Report on the status of work on the issue of electro-hydraulic systems, (ECE/TRANS/WP29/GRRF/2013/29)

Proposal for amendments to Regulation No. 13 (Heavy vehicle braking) and 13-H (Brakes of M₁ and N₁ vehicles)

A. Proposal for Supplement 11 to the 11 series of amendments to Regulation No. 13

"Annex 14 - Appendix

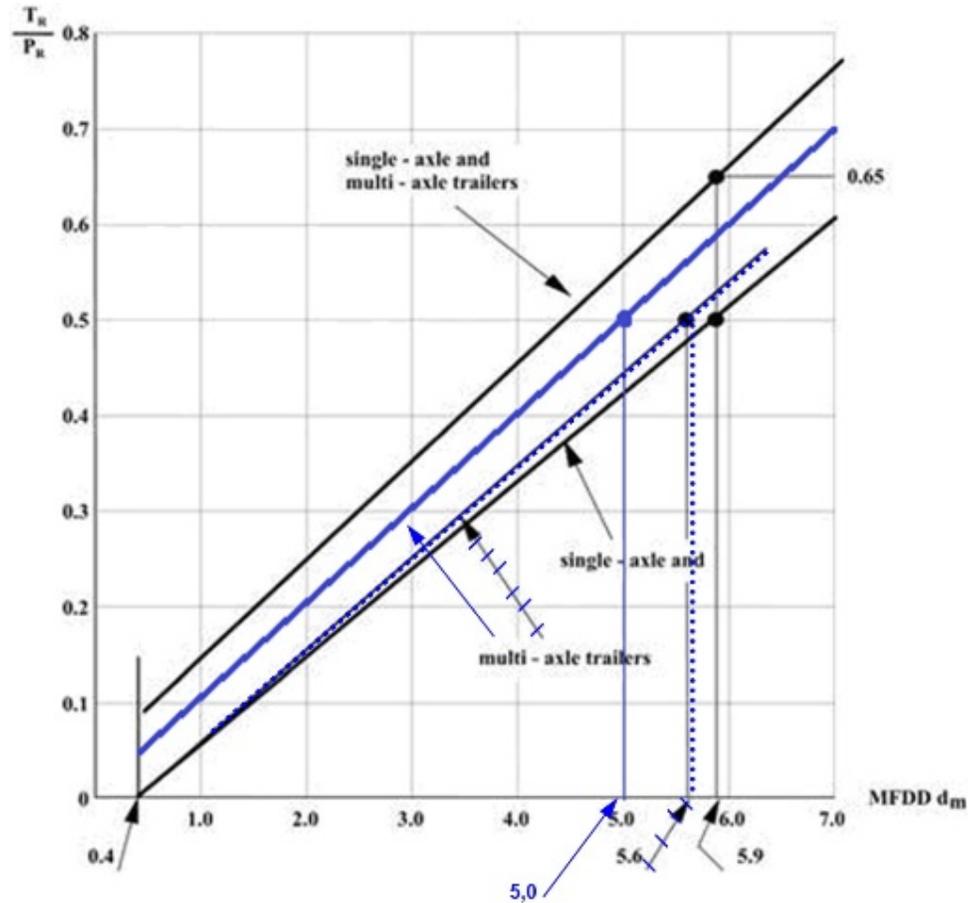
"3.4. The prescribed braking force of the trailer of at least 50 per cent of the maximum total axle load shall be attained - with maximum mass - in the case of a mean fully developed deceleration of the tractor/trailer combination of not more than 5.9 m/s² with ~~single axle~~ **centre-axle trailers and semi-trailers** and of not more than ~~5-6~~ **[5.0]m/s²** with ~~multi-axle~~ **full trailers**. ~~Trailers with close coupled axles where the axle spread is less than 1 m are also considered as single axle trailers within the meaning of this provision.~~ Moreover, the limits as defined in the appendix to this Annex shall be observed. If the braking force is regulated in steps, they shall lie within the range shown in the appendix to this Annex."

In the diagram the terms "centre-axle trailer" and "semi-trailer" shall be used instead of "single-axle trailer". The term "full trailer" shall be used instead of "multi-axle trailer".

11. *UN Regulation No. 13, Annex 14, paragraph 3.4 and Appendix (diagram),*

It is not clear which requirements should be applied to semi-trailers. The current requirements apply to single axle trailers and multi axle trailers. That could be interpreted as centre axle trailers and full trailers.

The prescriptions regarding the axle spread are not relevant if the terms "centre-axle trailer", "semitrailer" and "full trailer" are used.

Therefore the diagram in the appendix to Annex 14 also has to be amended accordingly.
